Access Compliance Report

Public Rights-of-Way

Intersection ID: 24097	Main Street: LIVINGSTON_MILL_RD	Cross Street: QUEENSWATER_LN	Location: NW
ADA ID: 4ADFFD4B973B	Ramp Type: Perp	Initial Pass/Fail: Fail	Overall Compliance: No
Severity Score: 21.25			
Codes/Mitigation Info/Possible Solution		Field Measurements/Component Compliance

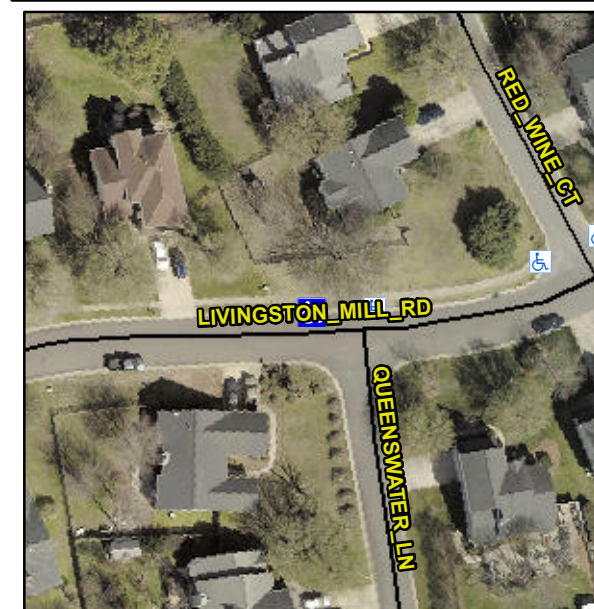
R304.5.1, R304.2.2

Remove & Replace Entire Ramp.
